REFERENCE LHC-TC-EC-0016

ENGINEERING CHANGE REQUEST

Installation of Low-Impedance Primary Collimators with BPMs (TCPPM) in IR7

Figure 1 — 3D view [5] of the TCPPM collimator. Top: full collimator, with RF fingers. Bottom: sketch with left jaw only to show the 60 cm active length (obtained through blocks of different thickness).

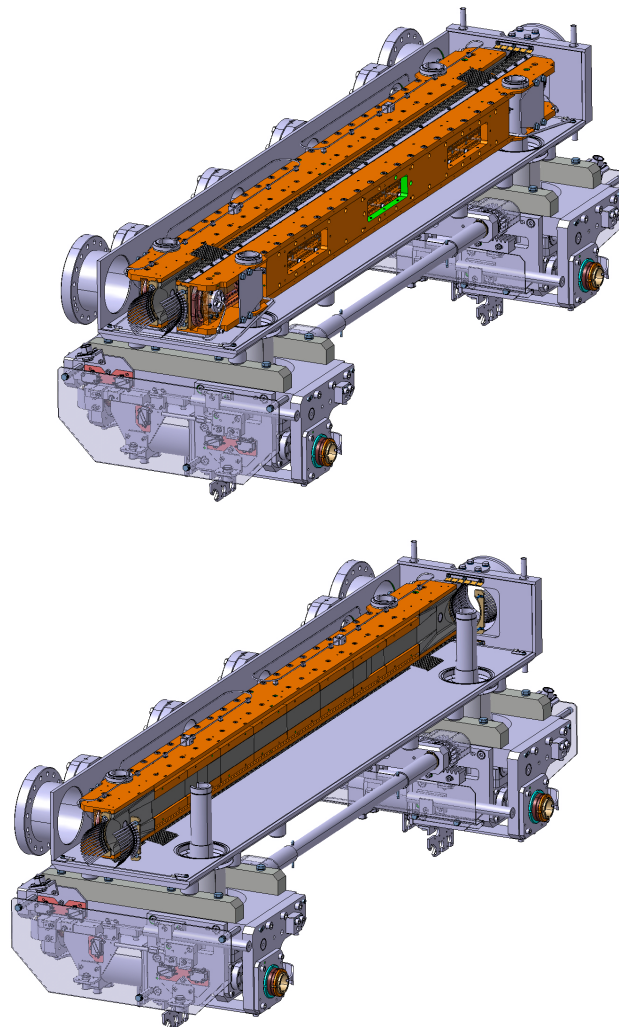
The present TCPPM design (see Figure 1) is similar to the one of the present TCPs [1]; among the most noticeable differences, there are the jaw material and the presence of Beam Position Monitors (BPMs). In fact, the design foresees jaws made of a composite material (MoGr) obtained from Molybdenum and graphite, chosen for its lower impedance and similar robustness with respect to the jaw material of the present TCPs (Carbon-Fiber-Composite, CFC). The new material is characterised by an impedance lower by about a factor 2 with respect to the one of CFC. The collimator jaws are equipped with BPM button pick-ups, for an easy determination of the beam closed orbit at the collimator and fast and precise alignment of the jaws. A third BPM is installed on the tank, to measure the beam position on the axis orthogonal to the one of cleaning.
